**Application by
Fingal County Council
for Waste Licence Application W0231-01
for Fingal Landfill, Co. Dublin**

***Replies to Request
for further information in accordance with
Article 14(2)(b)(ii) of the Waste
Management Regulations***

December 2006

Figure **21.3**

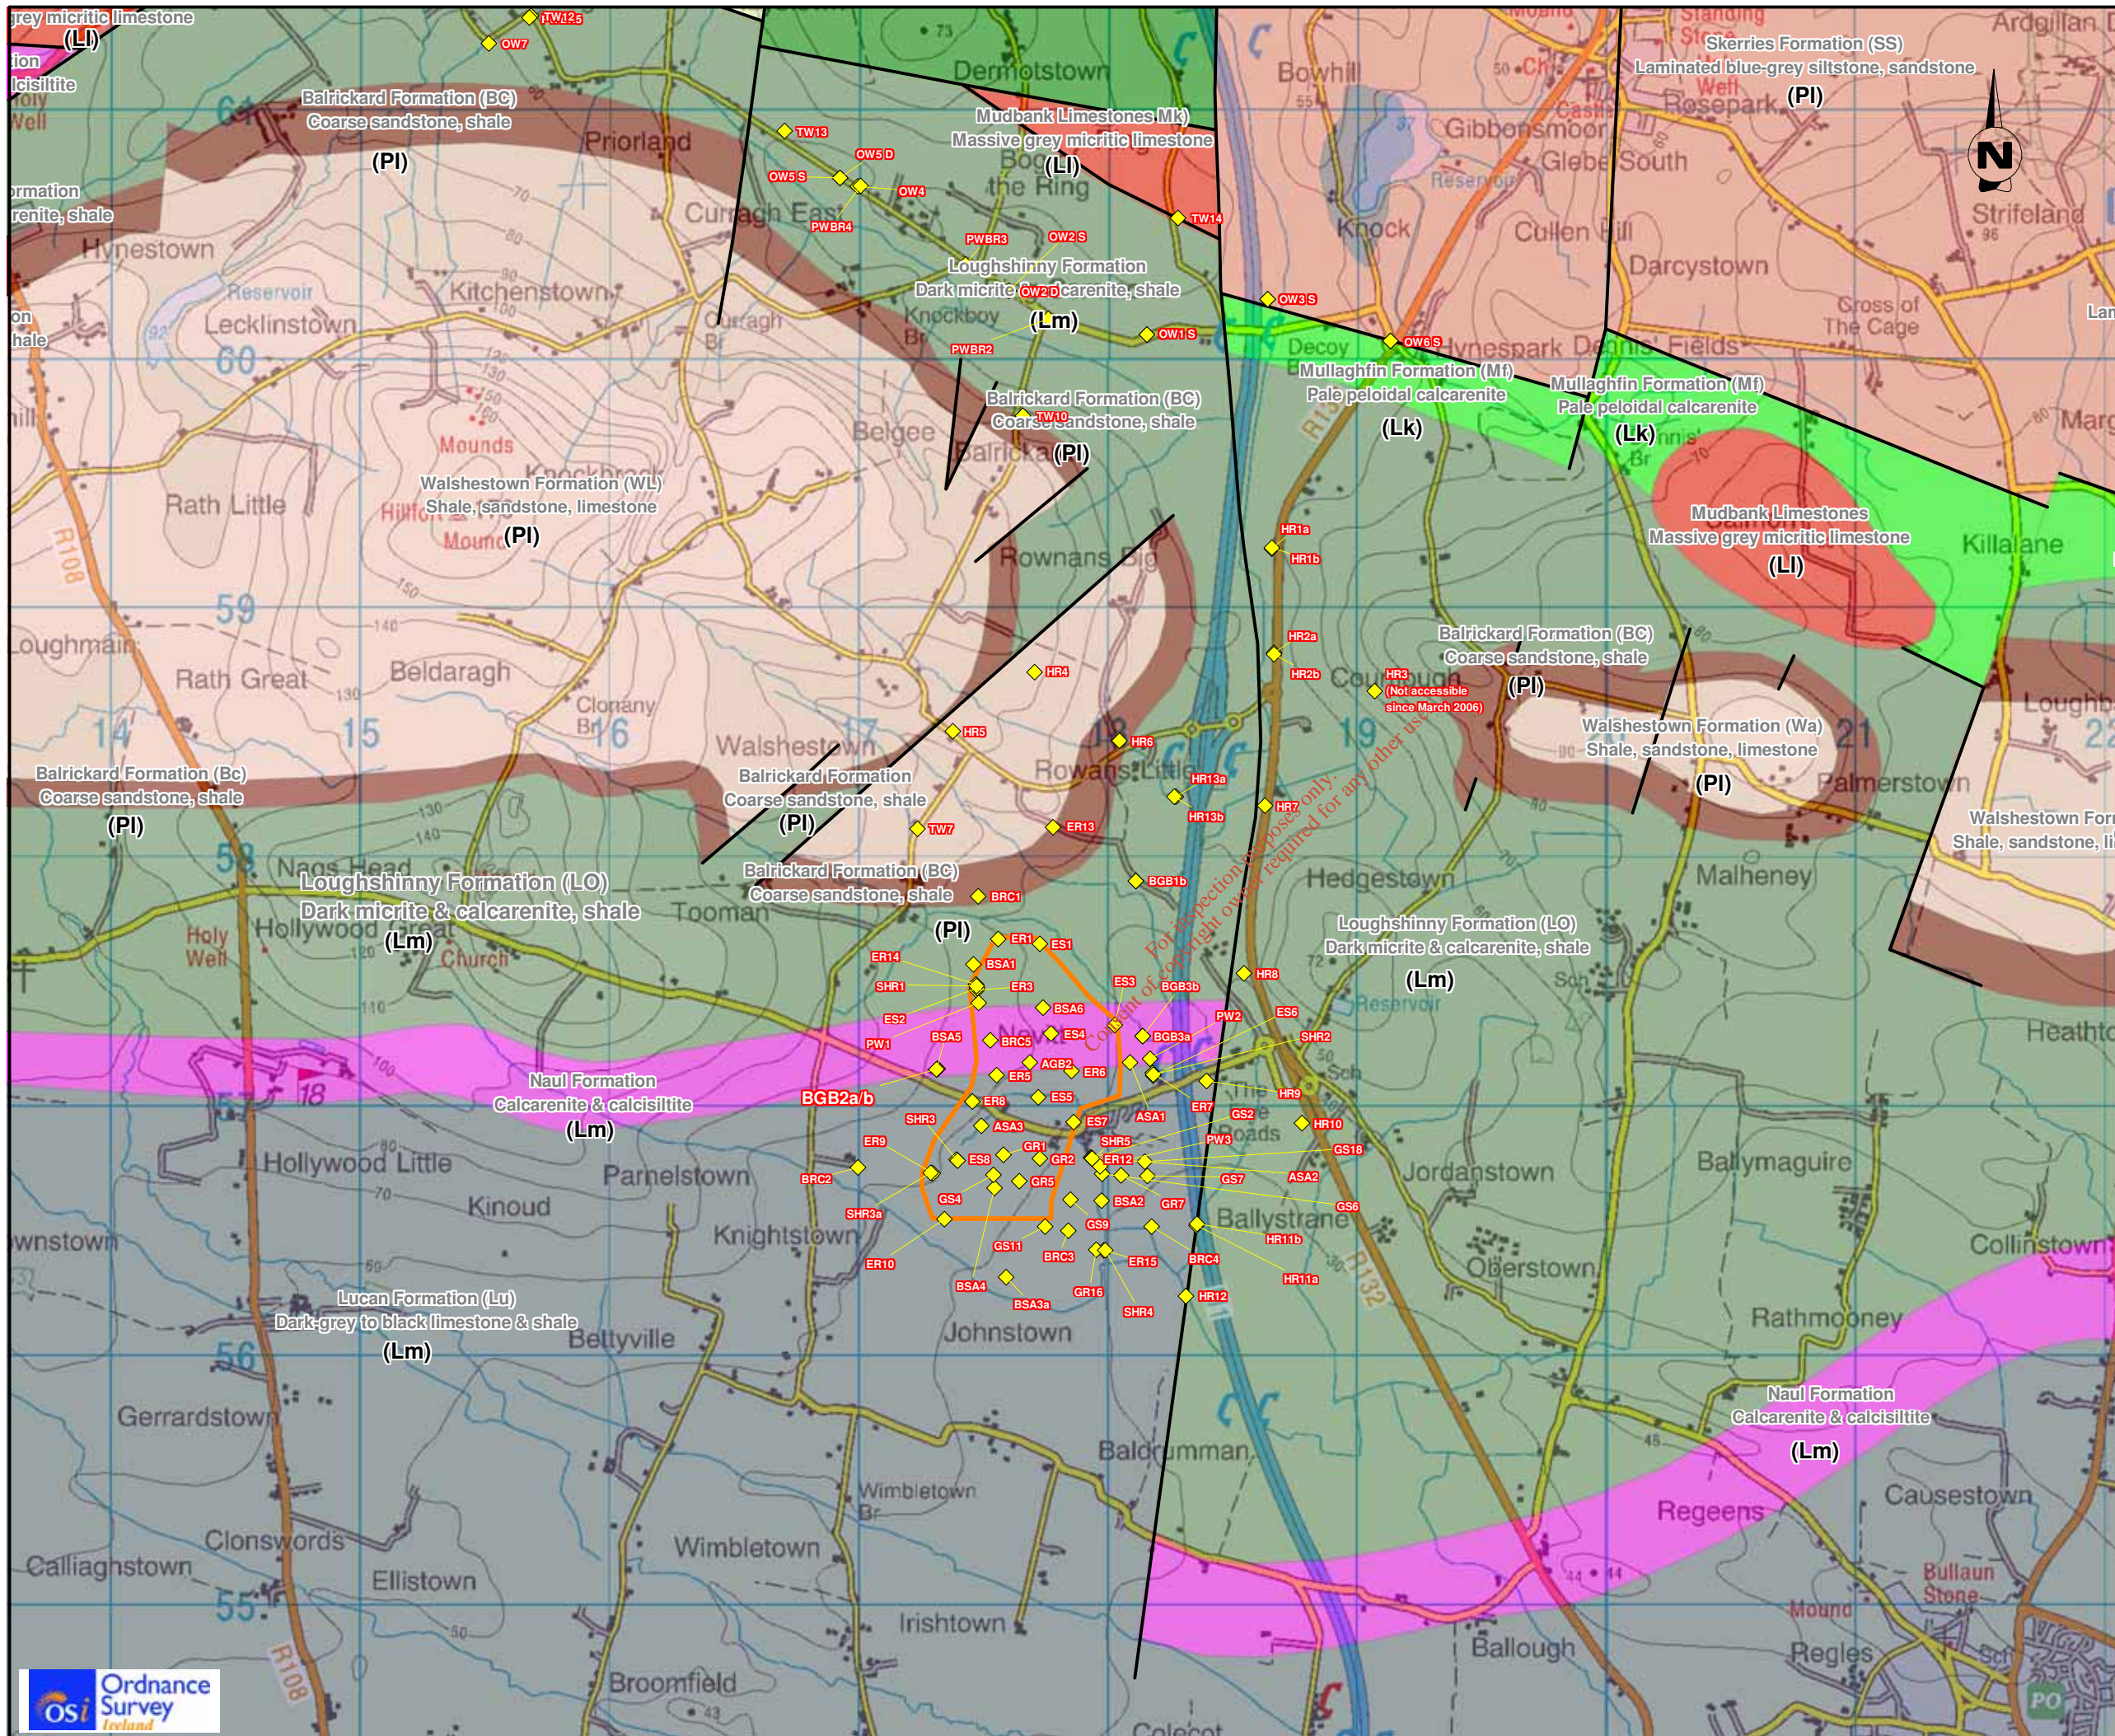
Cross referencing of Figure 8 (borehole locations) and Figure 4 (Bedrock Geology) indicates that BGB2 is in the Loughshinny Formation and not the Naul Formation. Please clarify and resubmit this part of the assessment.

- 4) Cross referencing Figure 8 and Figure 4 indicates that BGB2 is within the *Naul* Formation not the Loughshinny. To clarify, a map (**Figure 21.3**) is attached depicting underlying bedrock geology with bedrock borehole locations superimposed. The Naul and the Loughshinny bedrock formations have been grouped together by the GSI along with the Lucan Formation as the same Locally Important aquifer which is generally moderately productive (Lm).

BOREHOLE LOCATIONS

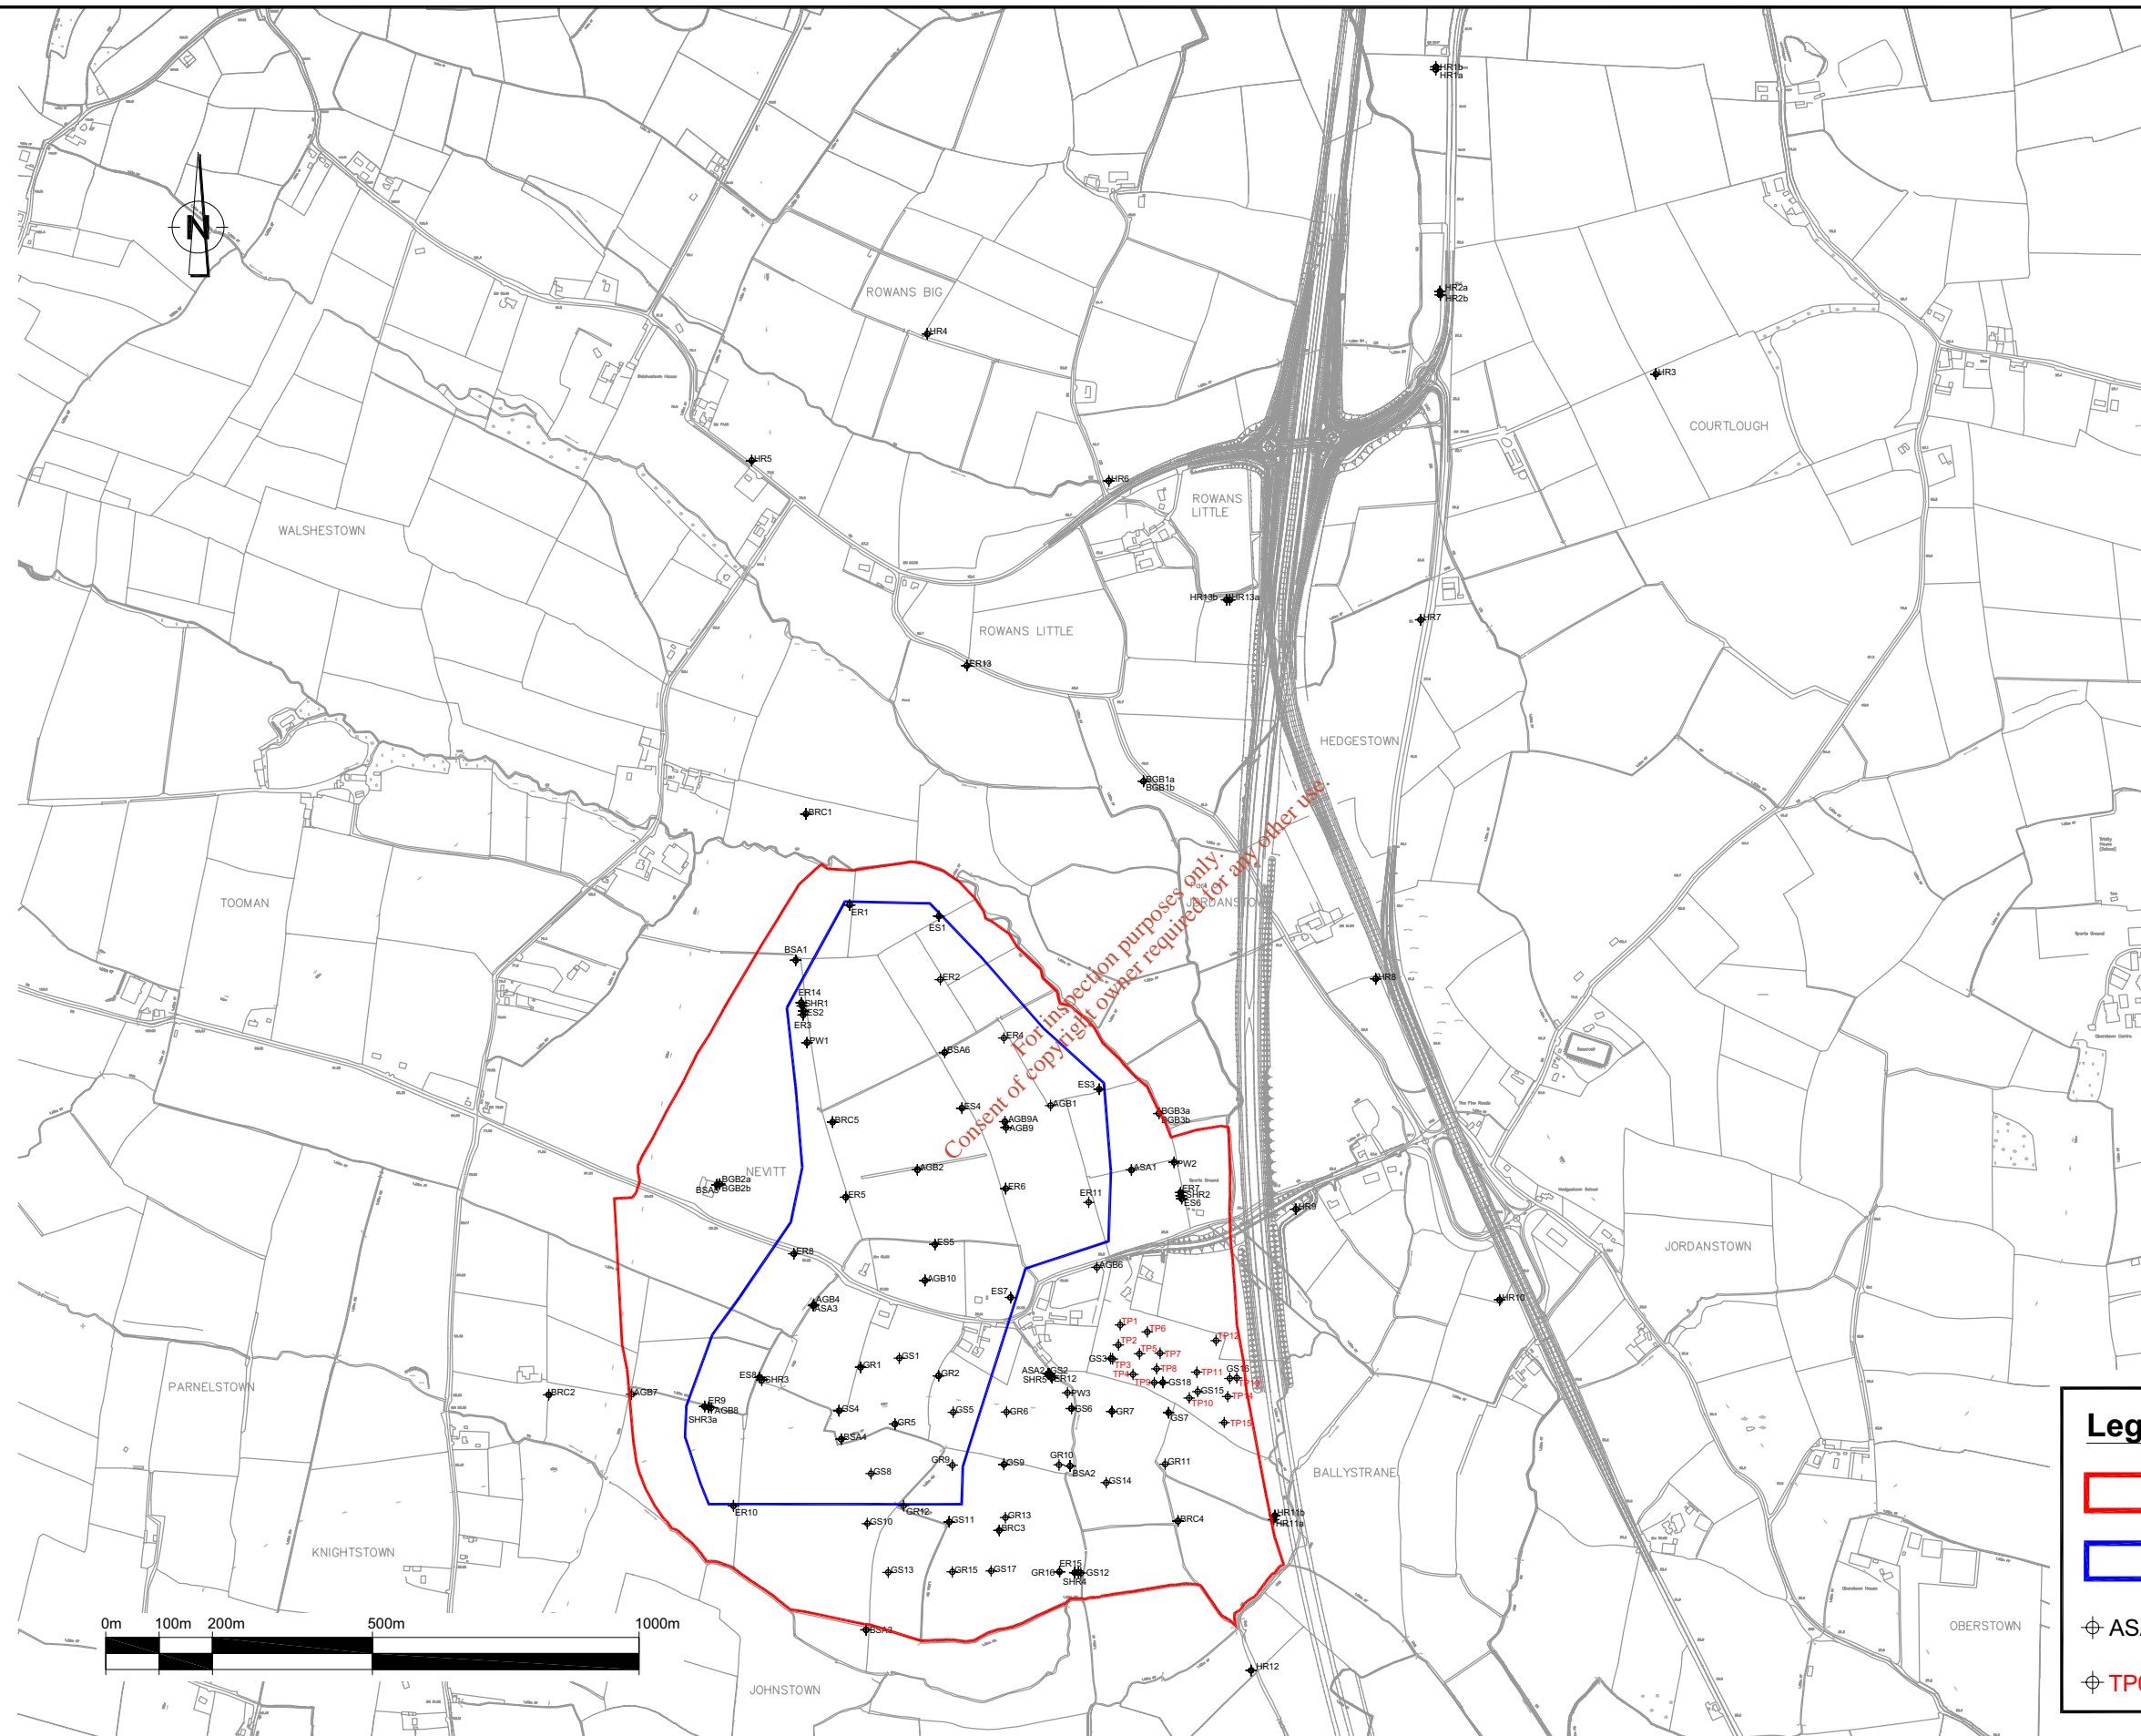
EIS volume 5 Factual Ground Investigation Report (No 9716) indicates the locations of BGB2 and BGB3 are switched when compared to Figure 8 referred to above. Given these inconsistencies please clarify the borehole locations and provide an assessment of the impact of any misinterpretations due to this inconsistency (e.g. impact on groundwater contours, aquifer productivity assessment and other assessments in which the data were employed).

Provide an A3 size drawing of the site area, including the following:

An A3 size drawing of the site area (**Figure 21.4**), landfill footprint; licensed area boundary and confirmed locations of all boreholes is attached.

Landfill footprint, licensed area boundary and confirmed locations of all boreholes are shown in **Figure 21.4**.

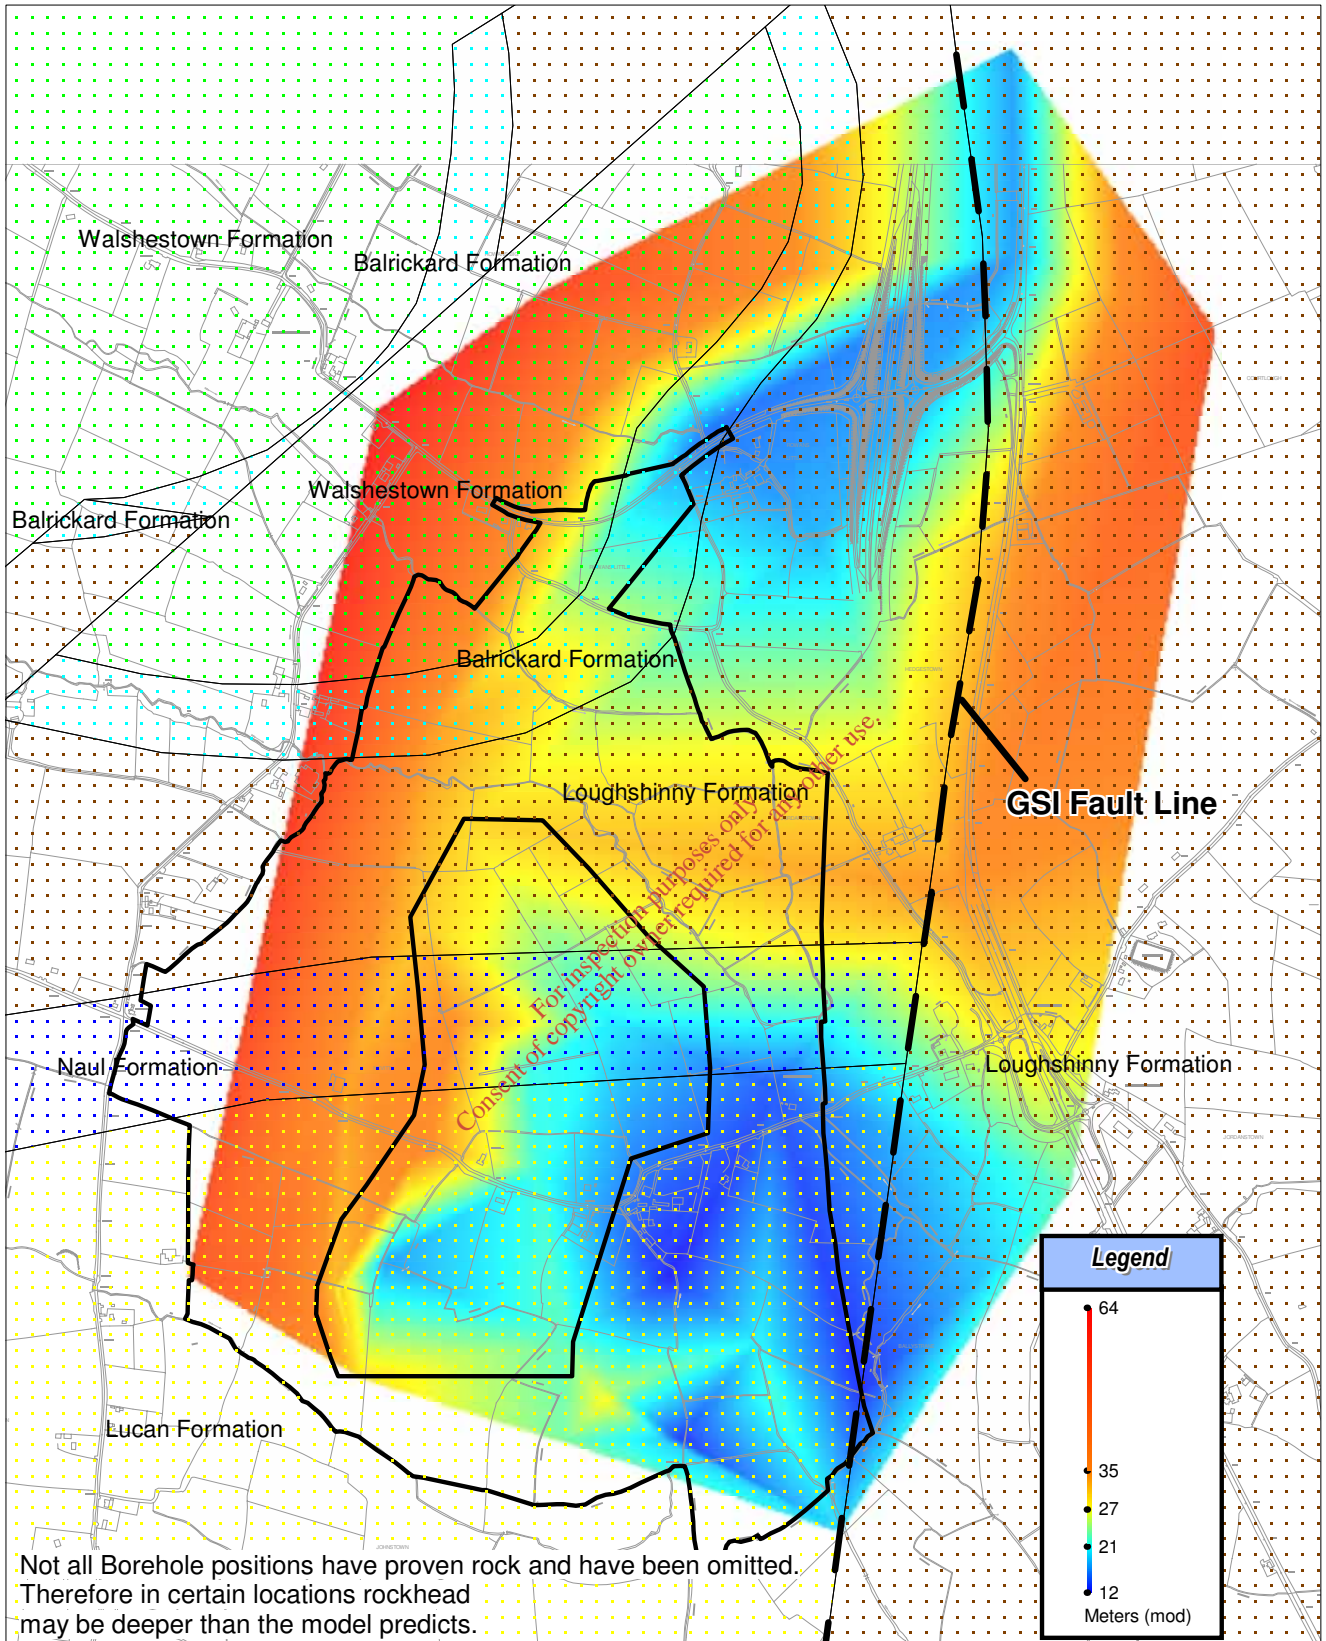
- 6) *Provide a bedrock contour map for the site area.*

A bedrock contour map depicting the elevation of the bedrock surface is given on **Figure 21.5**. In addition, the thickness of clay deposits underlying the site area has been provided in **Figure 21.6**. The clay deposits offer protection to the underlying groundwater quality.
